**PLANNING BOARD AGENDA**  
**MAY 13, 2021 – 7:00 P.M.**

RE: Carmel Fire Department  
94 Gleneida Avenue  
Town of Carmel  
TM# 44.14-1-24

Please find enclosed five (5) copies of the following documents in support of a site plan application revision for the above referenced project:

DRAWING: **LAYOUT AND LANDSCAPE PLAN**

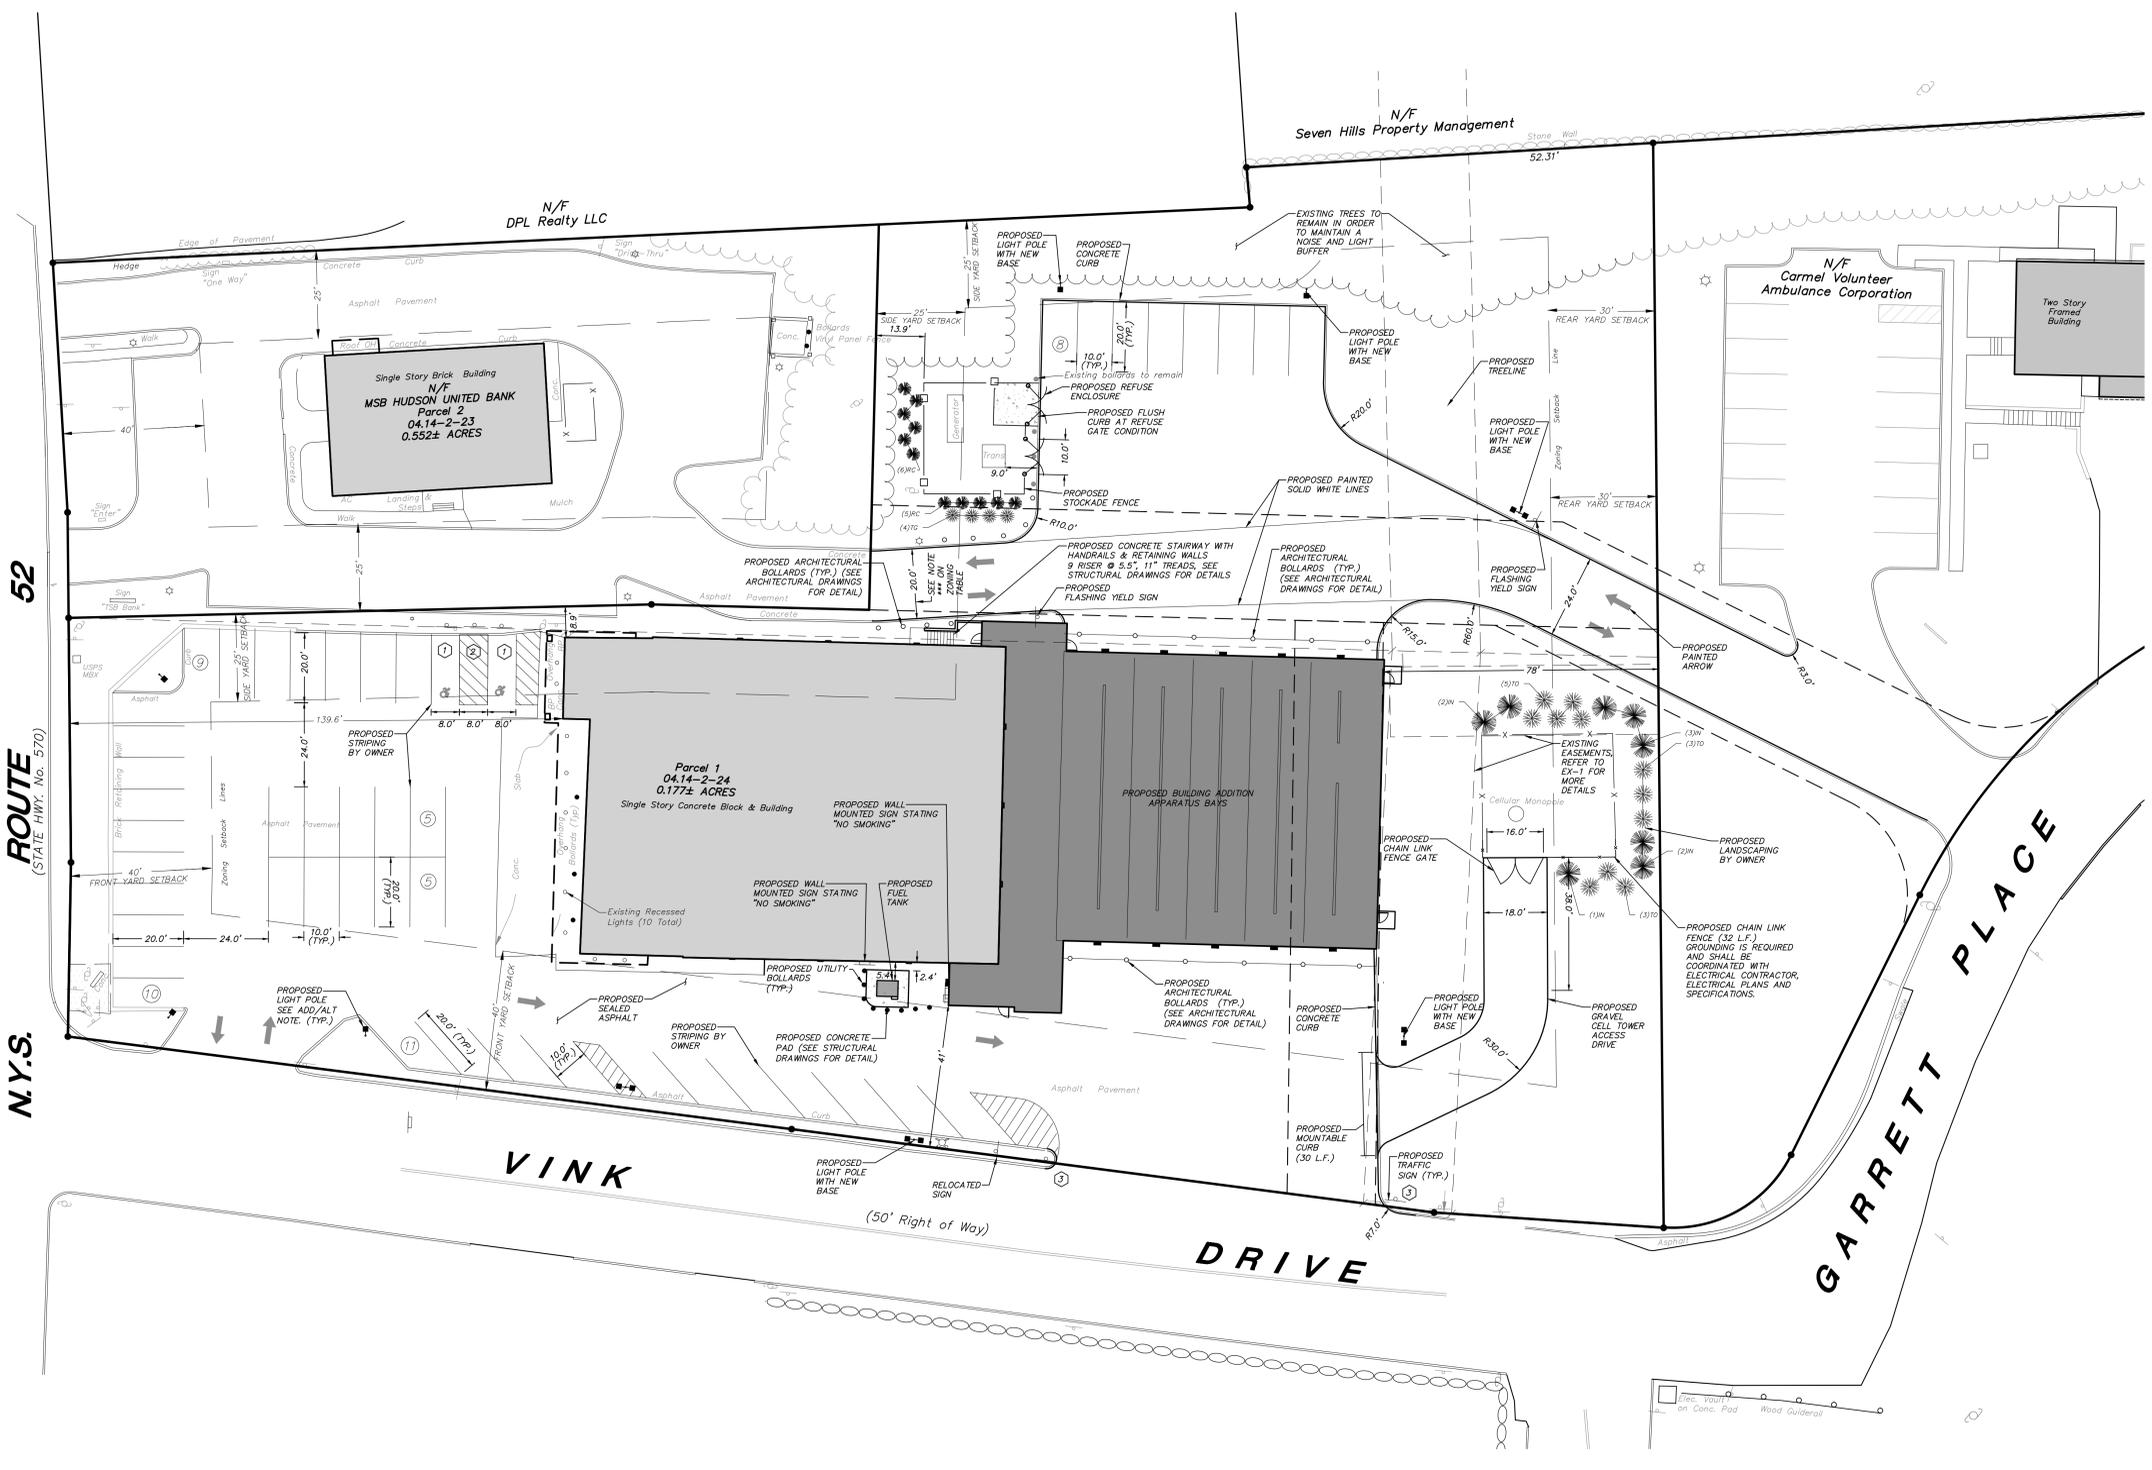
1. Per request of NYSEG and to assist the connection to the Bank's utility pole, a utility pole is proposed next to the utility enclosure. This has resulted in a change to the planting plan. NYSEG is requesting that limited plants be installed in this area. To maintain the intent of screening the enclosure as had been originally shown in the site plan drawings, but also comply with NYSEG regulations, the planting has been adjusted to clear the proposed pole and reduced in height in order to avoid wires. The landscaping continues to show evergreens in this area and total number of plants has remained the same.

3. The owner would like to seal the entire parking lot; therefore, striping will be replaced in kind in the front parking lot. Total parking numbers have remained the same.

DRAWING: **EROSION AND SEDIMENT CONTROL PLAN**

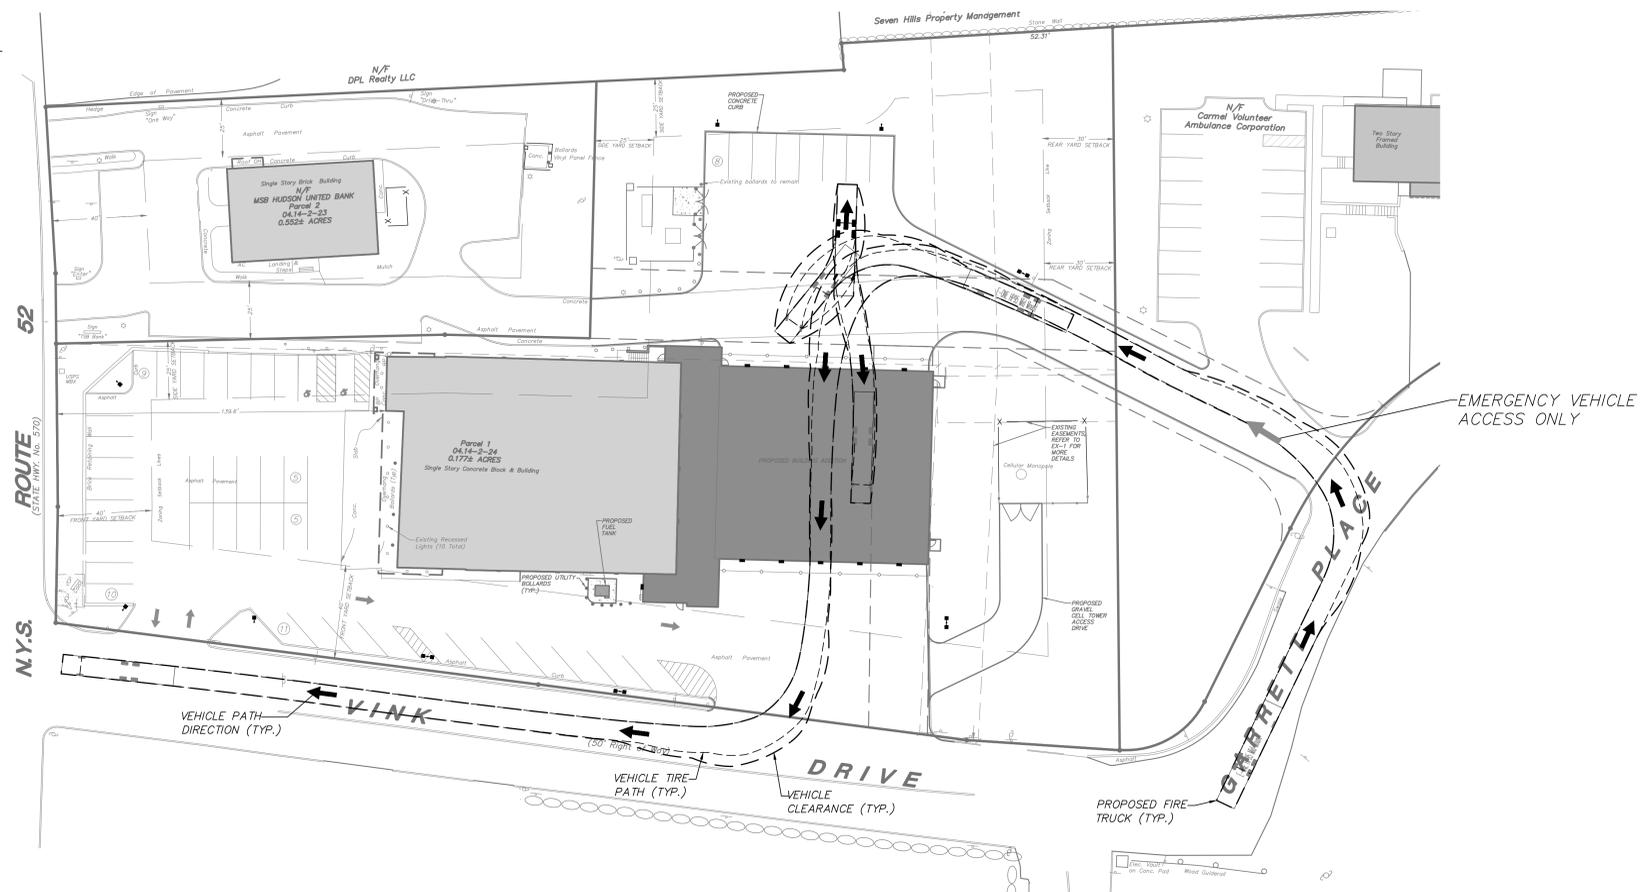
4. The erosion and sediment control plan has been supplemented with information to provide better protection and maintenance of traffic flow during construction.
